## MICROLIGHT AIRWORTHINESS APPROVAL NOTE

MAAN NO: 2073

TITLE: Microlight Airworthiness Approval Note 2073,  
Shadow Service Bulletin BMAA 2073.

<i>Title: Shadow variants: <b>Inspection of hanger tube brackets</b></i>	
<i>Reference: <b>SB BMAA MAAN 2073 issue 1</b></i>	<i>Applicability: <b>All UK Shadow variants administered by the BMAA</b></i>
<i>Issue date: <b>30 March 2007</b></i>	
<b>Recommend inspection.</b>	
<b>This SB should be actioned before the next Permit Revalidation inspection.</b>

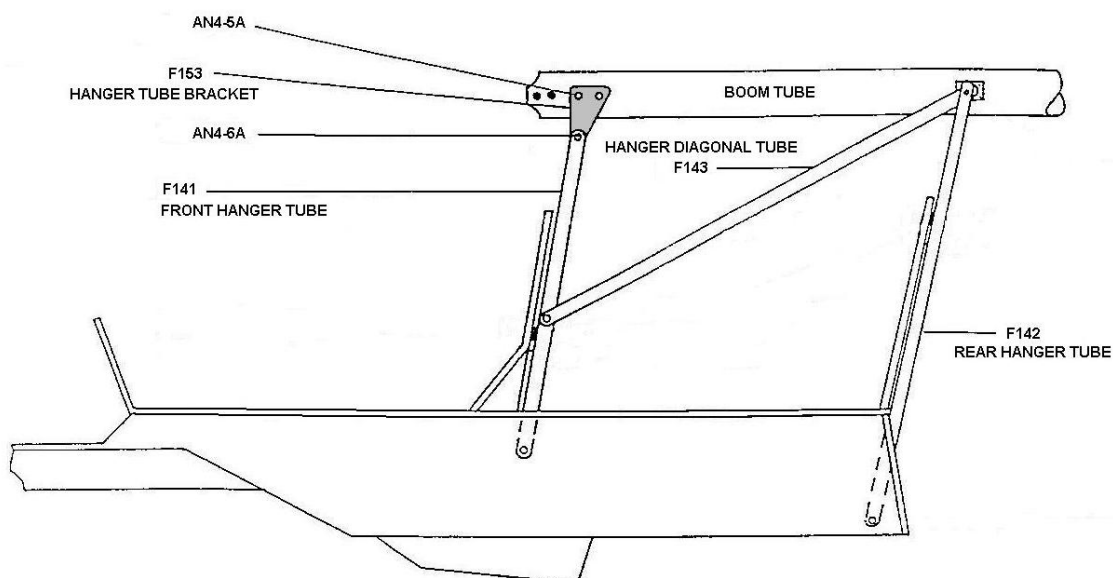
1. Firmly chock the main wheels to prevent them moving during the inspection.
2. From the rear cockpit, equipped with a good light source, inspect the F153 plates for cracks and any evidence of movement or fretting within the hanger tube and the bolts for tightness.

3. Whilst inspecting the plates, ask a helper to gently push the wing fore and aft and check visually, and by feel, for any signs of movement between the plate and the hanger tube.

4. Next try using a firm vertical force applied at the point where the wing strut attaches to the wing. **WARNING:** do not exert lifting pressures ant the wing tip.

5. Repeat steps 3 & 4 on the other wing.
6. Any evidence of undue movement or fretting should be investigated. If unsure, the F153 may be removed from the aircraft for a detailed inspection. If everything appears normal, then return the aircraft to service.
